BOARD ACTION REPORT – APPEALABLE ITEM

Project Name: Delray Beach Ford

SITE PLAN REVIEW AND APPEARANCE BOARD STAFF REPORT

File No.: 2019-112-
SPM-SPR-CL3

LANDSCAPE PLAN

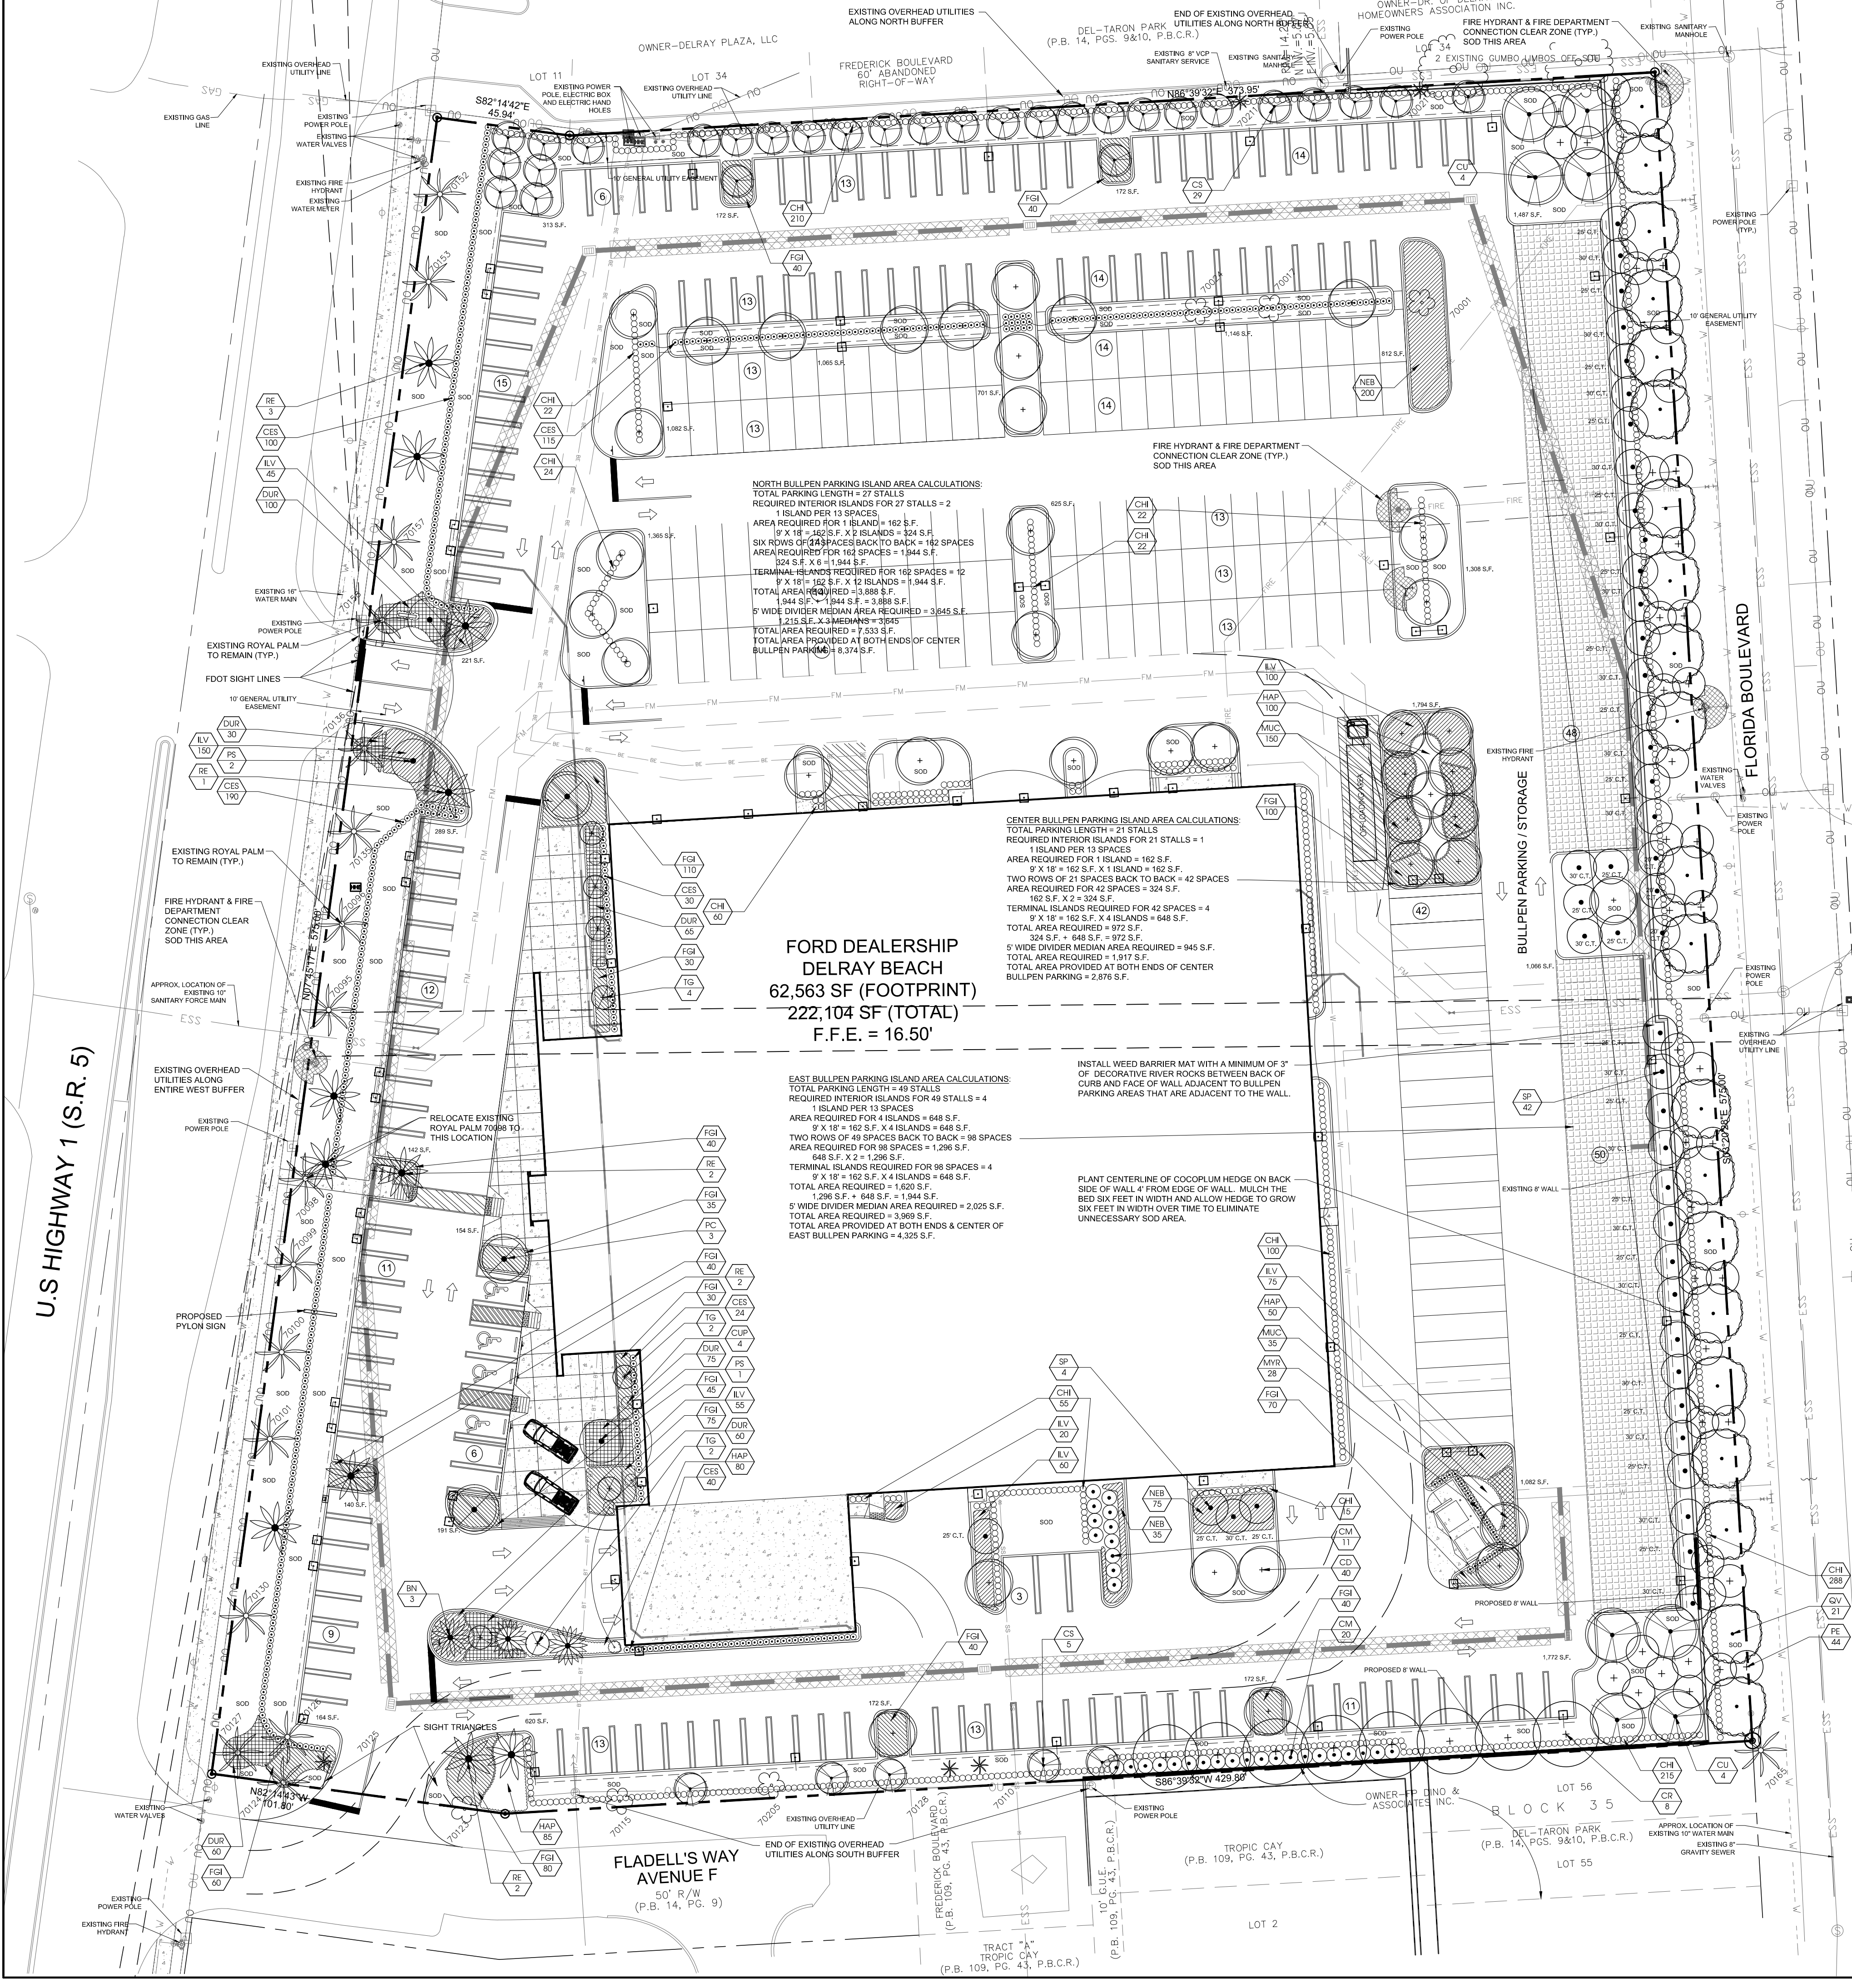
A landscape plan has been submitted and evaluated by the City's Senior Landscape Planner. The changes to the approved landscape plan occur on the north and south sides of the building due to the reconfiguration of the landscape islands. The modification is minor and does not significantly impact the aesthetics of the development and continues to comply with the landscape requirements.

Exterior Building Elevation : NORTH VIEW

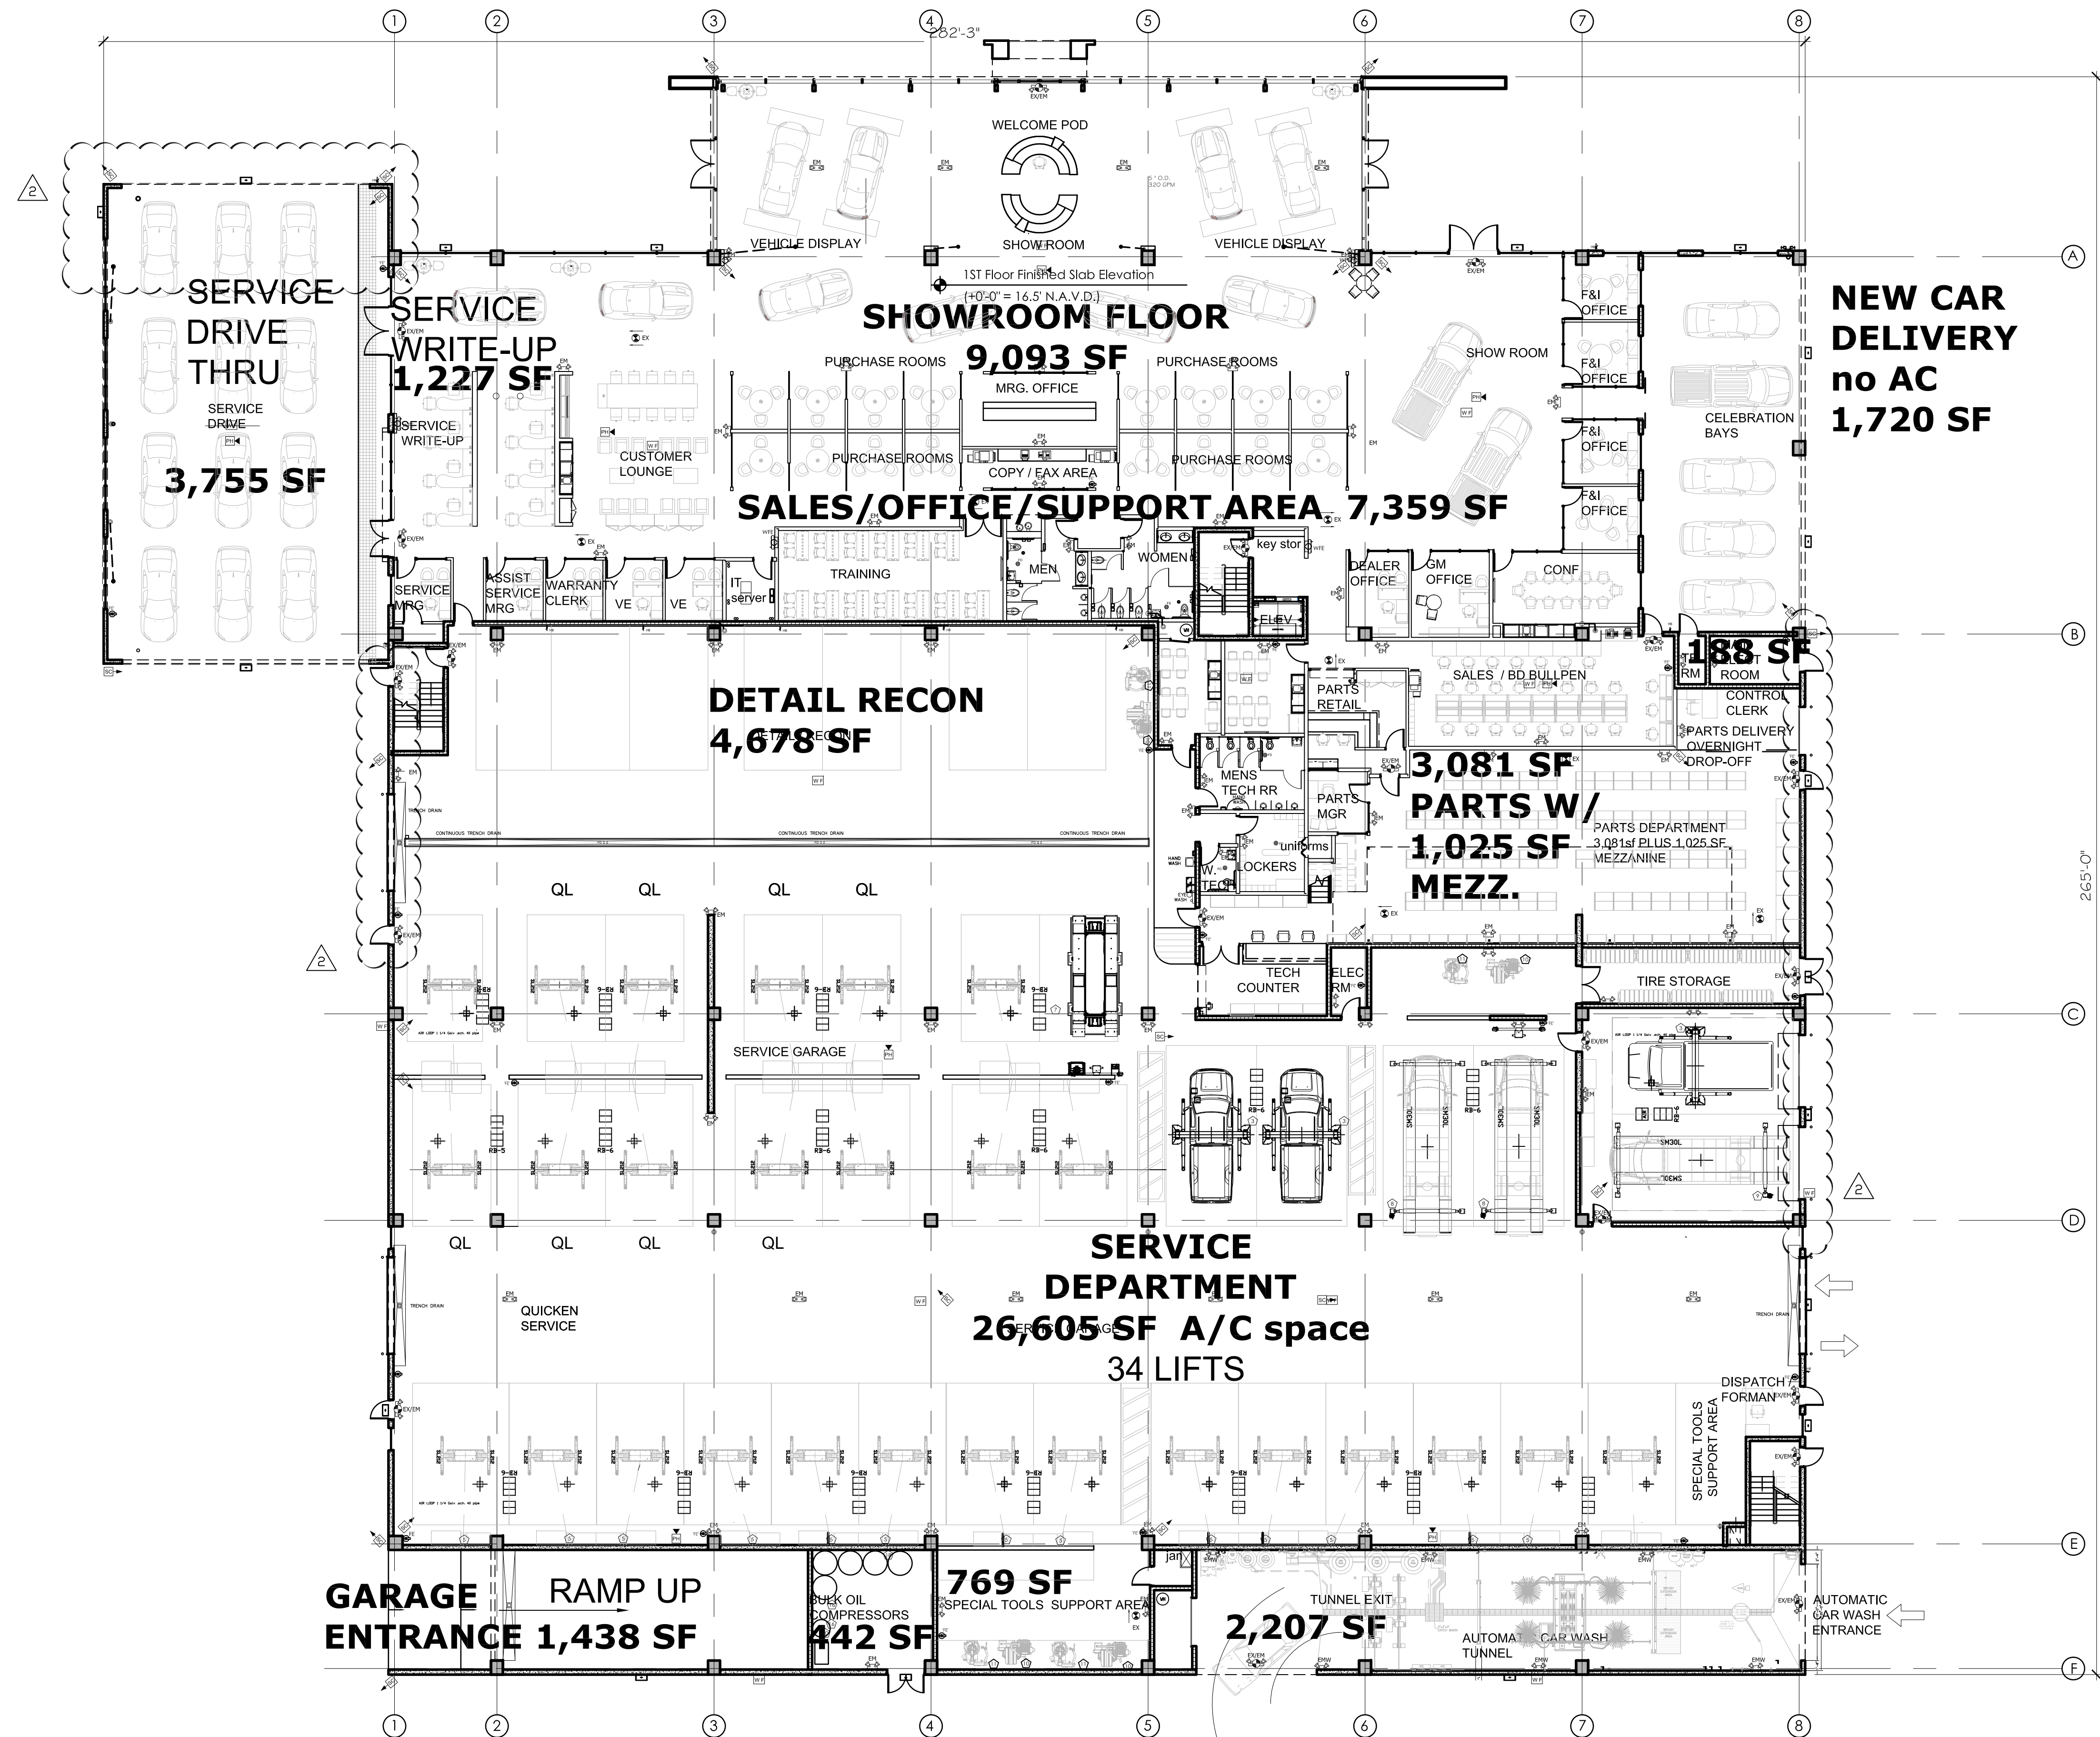
Due to the interior reconfiguration of the floor plan and locations of service, storage, and repair facilities, the locations of the overhead doors were modified on the north and south elevations. These two elevations are not visible from Federal Highway or does not impact adjacent residential or commercial uses. Thus, a positive findings with respect to LDR Section 4.6.18(E) is made.
